**SUBJECT:** Lodi Energy Center (08-AFC-10C)  
Staff analysis of proposed modifications to Air Quality Conditions of Certification regarding emissions, combustor tuning definitions and limits, and fuel flow meter specifications.

# LODI ENERGY CENTER (08-AFC-10C)

## Petition to Amend Carbon Monoxide Start-up Emission Limit and Other Minor Air Quality Changes Joseph Hughes July 8, 2013

**Air Quality Figure 1**

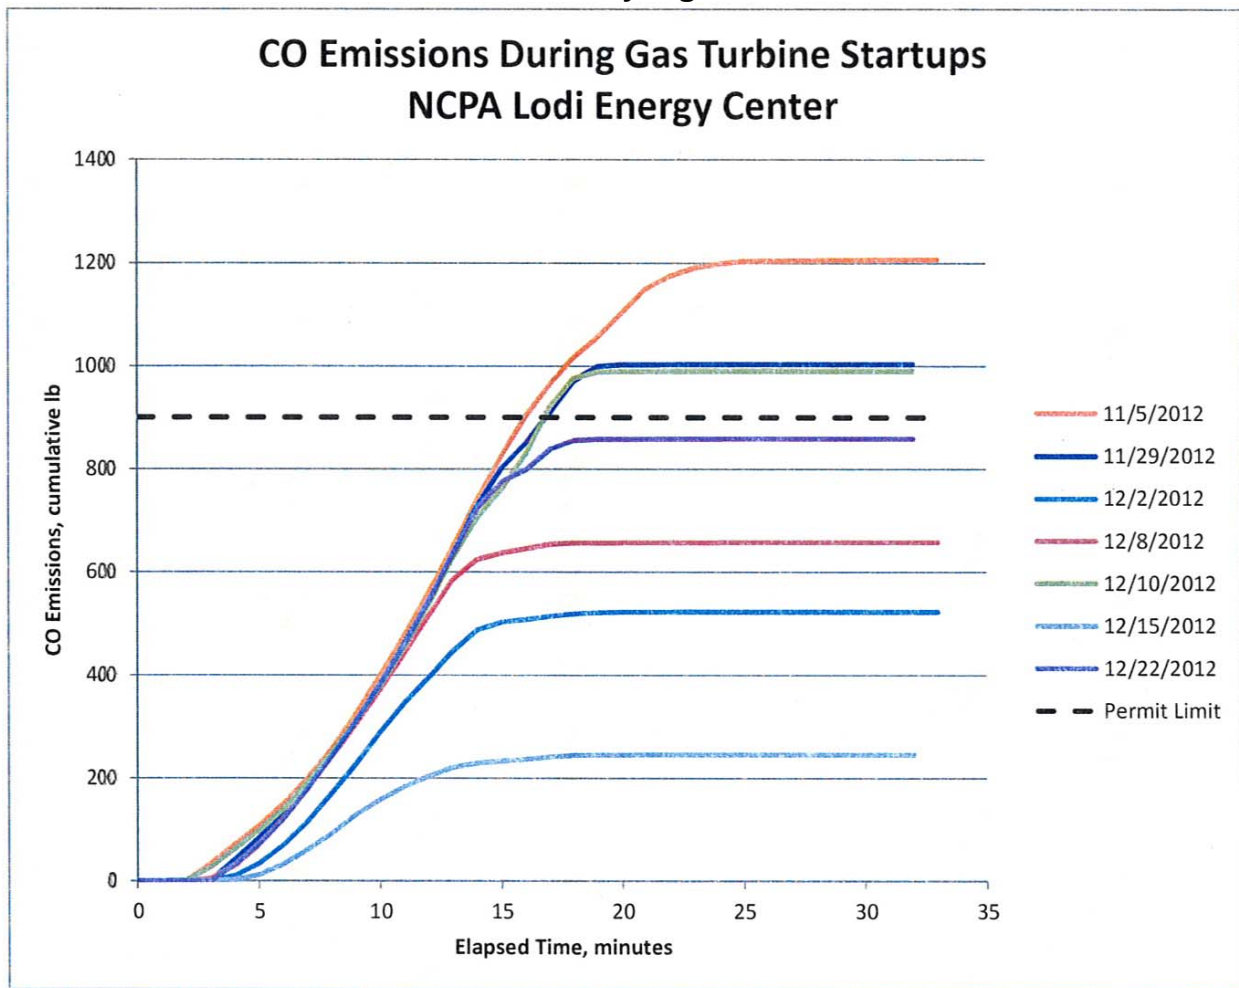
The Final Commission Decision limits CO emissions to 900 lb/hr. This limit was proposed by NCPA in the AFC and was based on start-up data from other similar gas turbines. However, now that the plant is operational, NCPA has found that under certain conditions (e.g. low load and low ambient temperatures) CO emissions are higher than originally expected. Under these conditions, continuous emission monitoring at LEC has indicated that CO emissions can be as high as 1,207 lb/hr during a cold start. After discussion with the SJVAPCD permit engineer, NCPA is proposing to add a compliance margin of 25 percent to the highest measured emission rate to ensure future compliance. Therefore, NCPA is proposing to modify COC **AQ-25** to limit CO emissions to 1,500 lb/hr during start-up and shutdown periods. NCPA is not requesting any changes to daily or annual emission limits. No additional ERCs or mitigation would be required because the annual emission limit for CO would remain the same and the

entire state is in attainment for CO. **Air Quality Figure 1** shows how cumulative pounds (lb) of CO emissions from the LEC combustion turbine vary during start-up.

The proposed increase in start-up emissions from 900 lb/hr to 1,500 lb/hr is lower than the previously analyzed and approved commissioning period impacts for the LEC at 2,000 lb/hr, which did not lead to adverse impacts at this emission rate. Therefore, no significant impacts would occur at 1,500 lb/hr. Nonetheless, **Air Quality Table 1** provides the revised modeled maximum impacts during start-up operations. The original 1-hour and 8-hour impacts, as identified in the Final Commission Decision, were 337.3 ( $\mu\text{g}/\text{m}^3$ ) and 110.2 ( $\mu\text{g}/\text{m}^3$ ) respectively. The revised 1-hour impact was obtained by scaling the maximum hourly emission rate of 900 lb/hr to 1,500 lb/hr and multiplying by the original maximum facility impact. In the Commission Final Decision, the 8-hour impact was modeled assuming that the gas turbine was in start-up mode for six hours and at base load under cold temperature conditions for two hours, for a total of 5,408 lb CO over the 8-hour period. The revised maximum 8-hour impact is evaluated by assuming all maximum daily emissions (5,570.3 lb/day) occur in an 8-hour period. Even
